COUNCIL ACTION FORM

REQUEST: **BRICK TOWNE MAJOR SITE DEVELOPMENT PLAN**

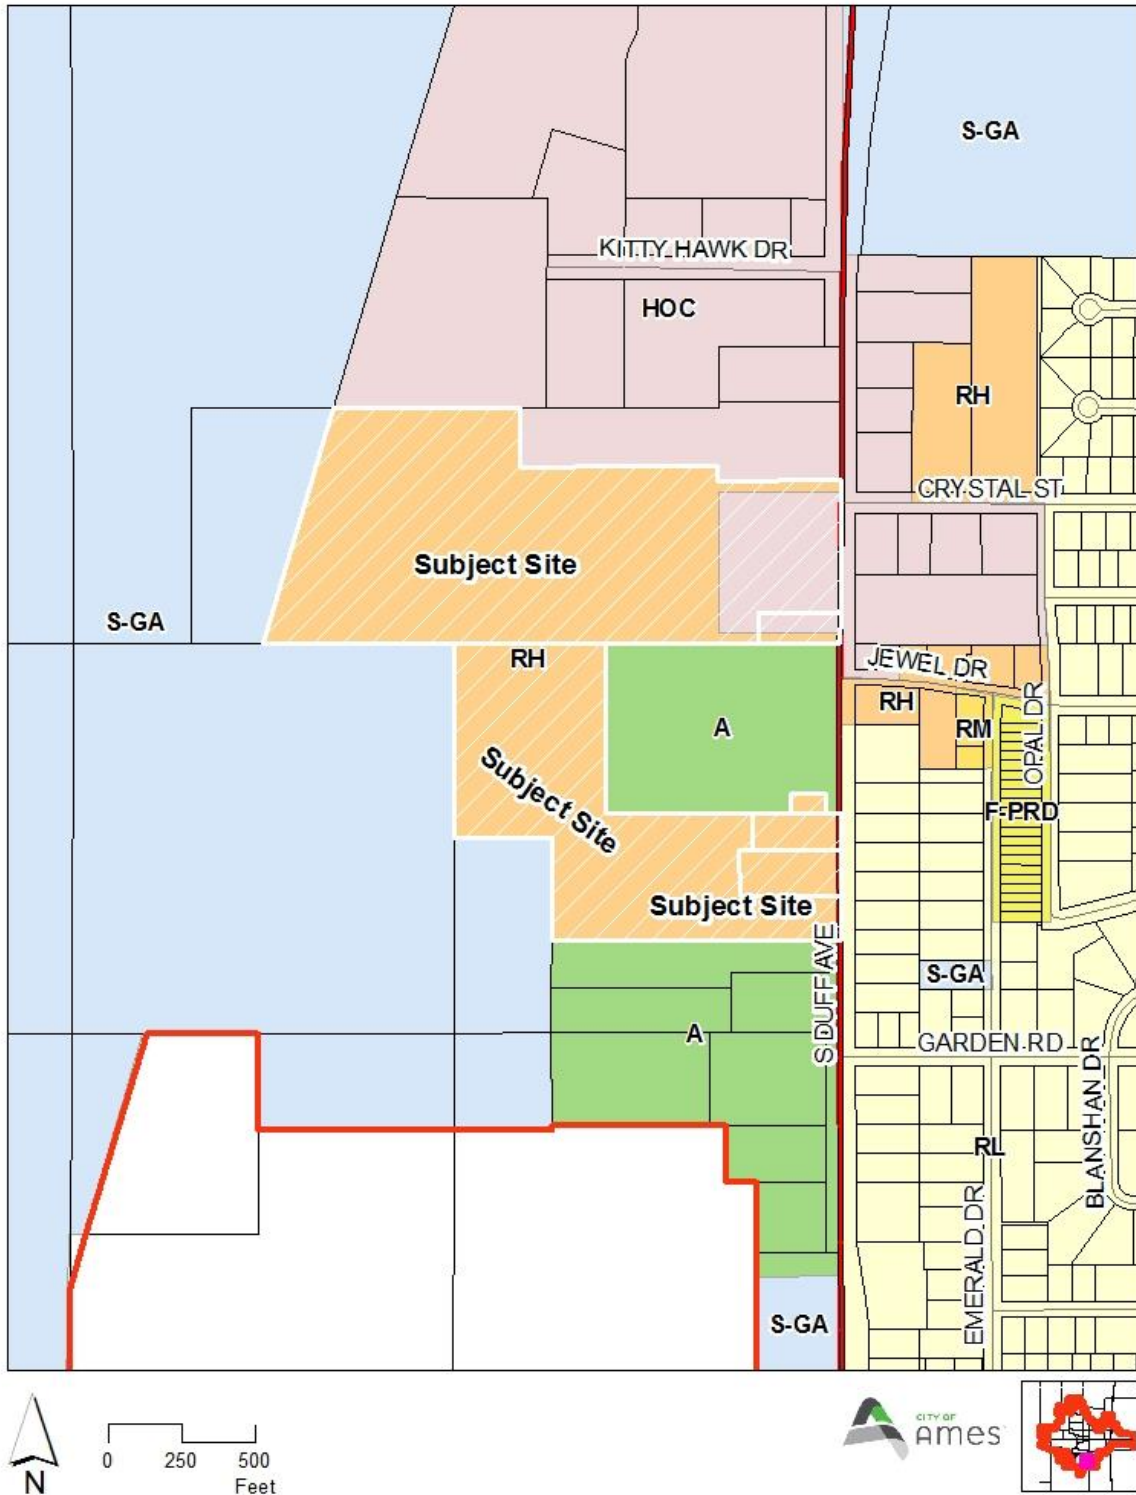
Features of the landscaping plan are:

- Overstory trees line the major private streets as if they were public streets.
- Berms, overstory and ornamental trees, and ornamental grasses provide a multi-level buffer to the commercial lots along South Duff Avenue.
- Berms, overstory and ornamental trees, and ornamental grasses provide a multi-level screening of the apartments from the South Duff Avenue right-of-way.
- Overstory trees adjacent to the parking areas provide shade.
- Ornamental grasses serve as mechanical unit screening and foundation plantings.
- Turf grasses adjacent to buildings.
- Prairie seed mix around the storm water features and on the periphery of the site.

JENSEN GROUP
BRICK TOWNE - SOUTH AMES
GREENSPACE EXHIBIT

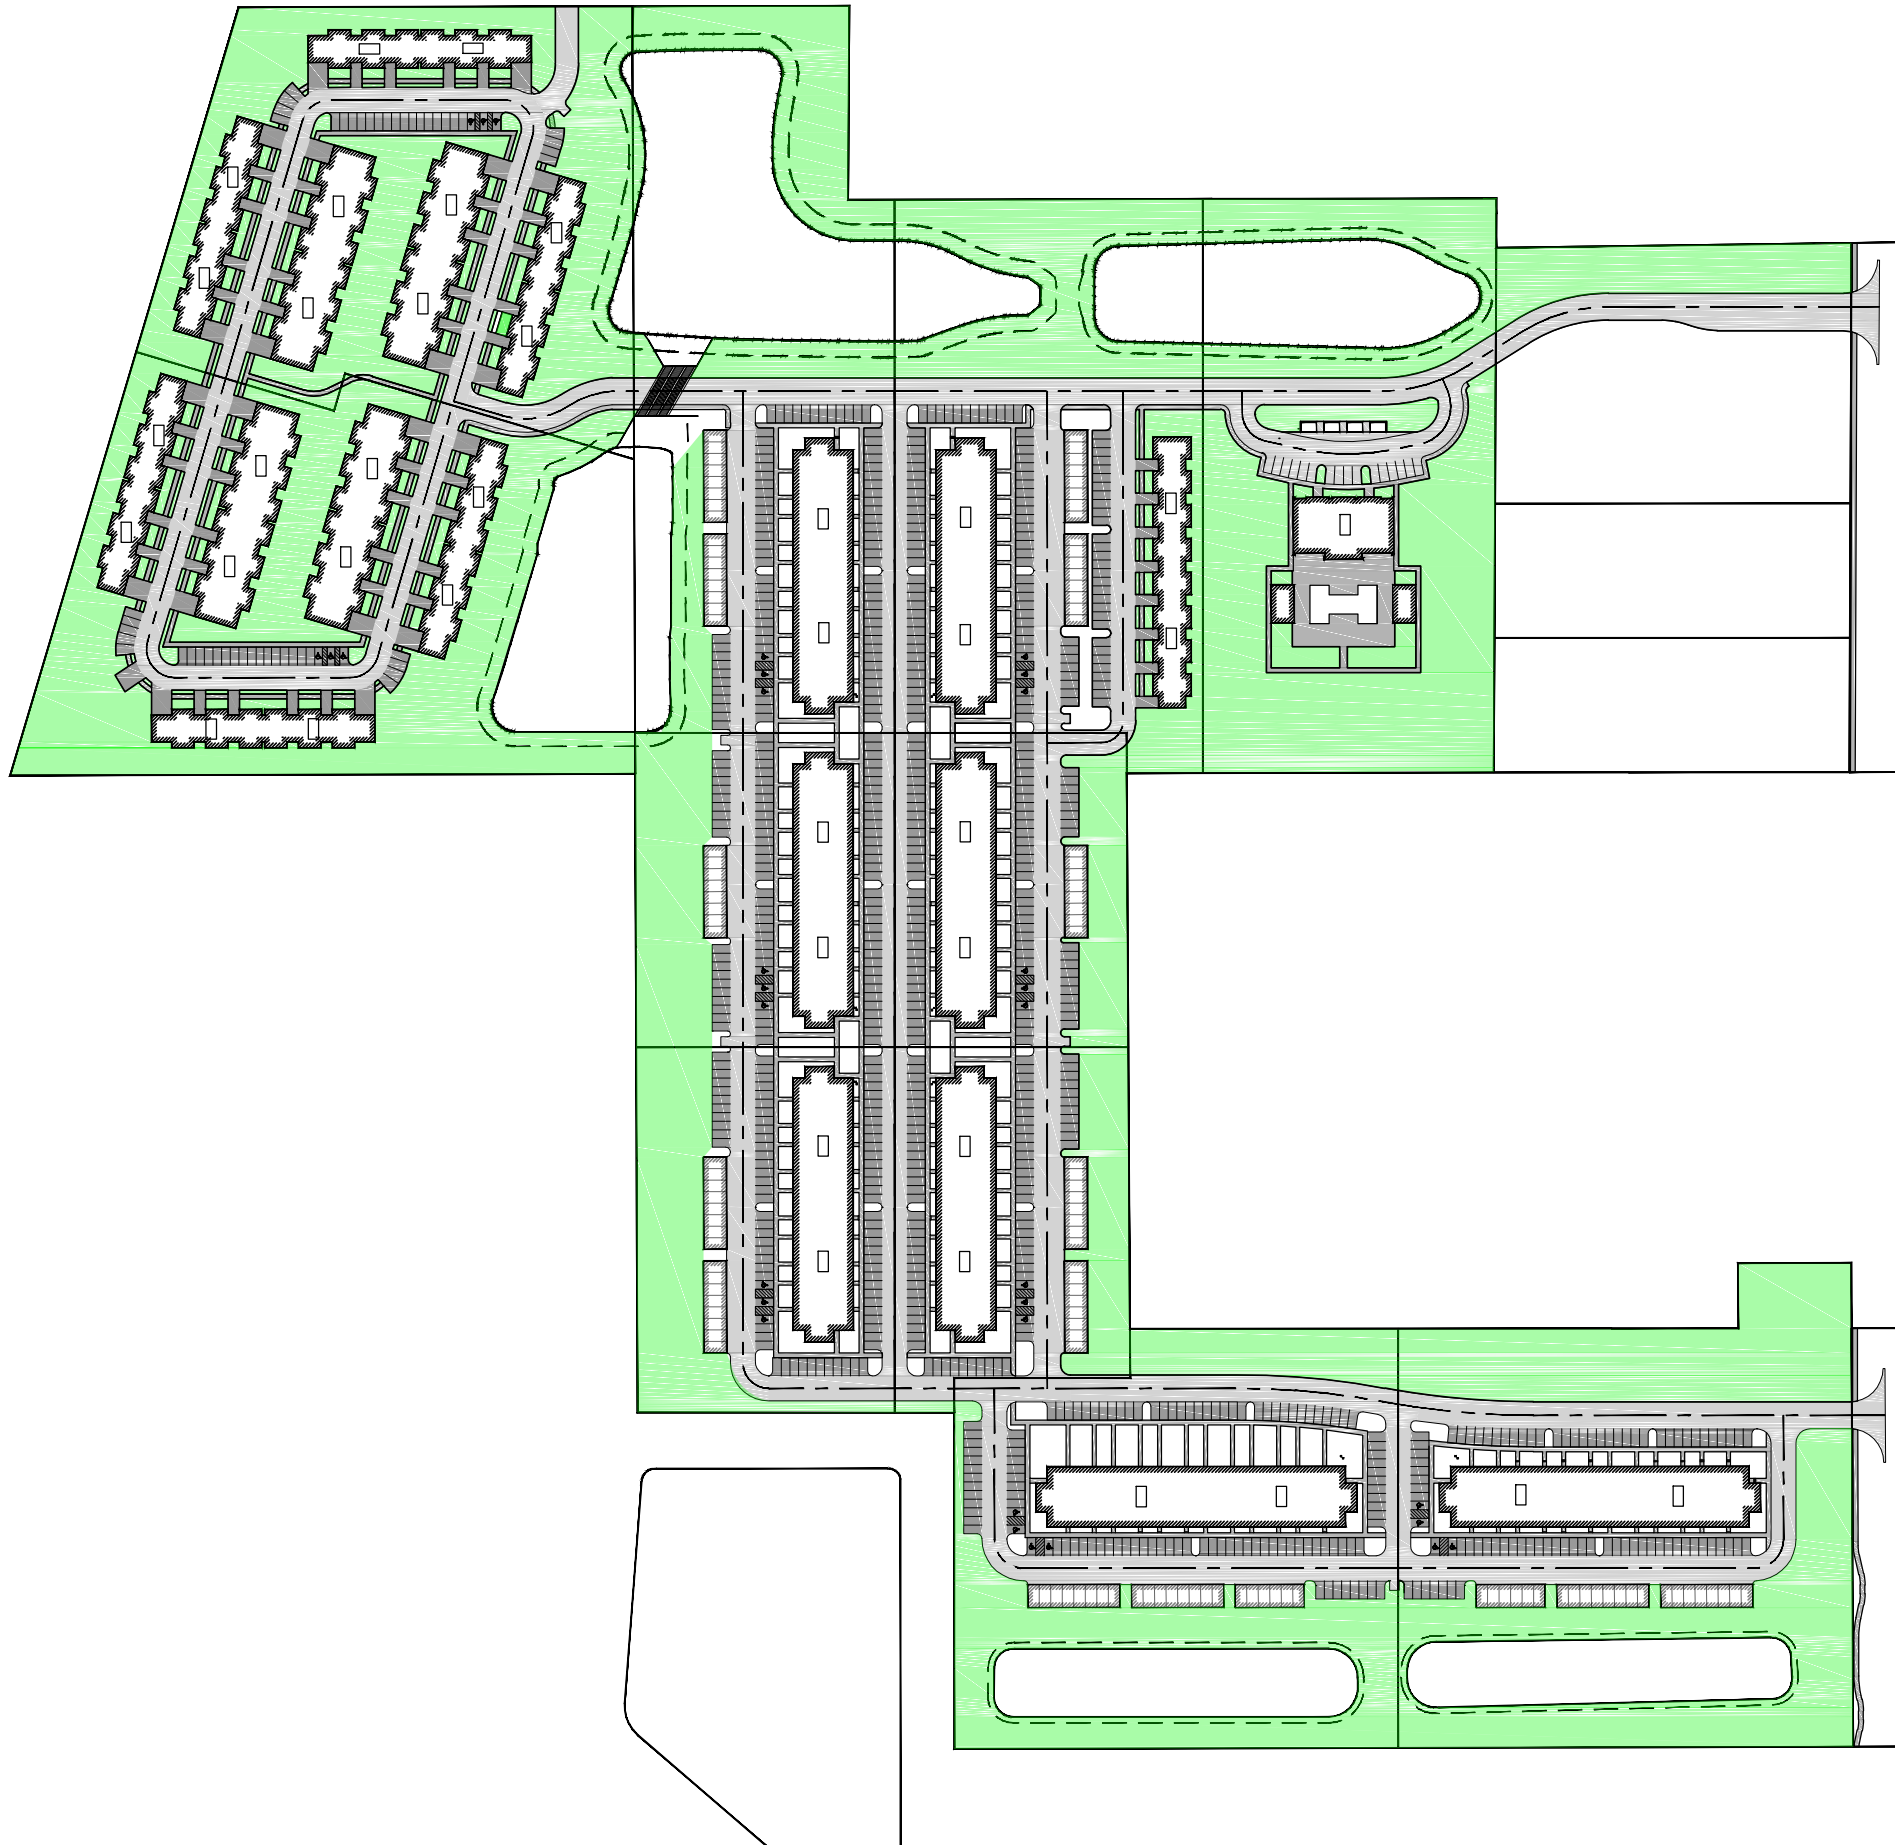
A minimum landscaped open space requirement of 35 percent is required for the F-PRD with a RH base zone. The overall project is noted to provide 38% open space. The common open space proposed will be maintained by the developer. This meets the requirements of the F-PRD zone.
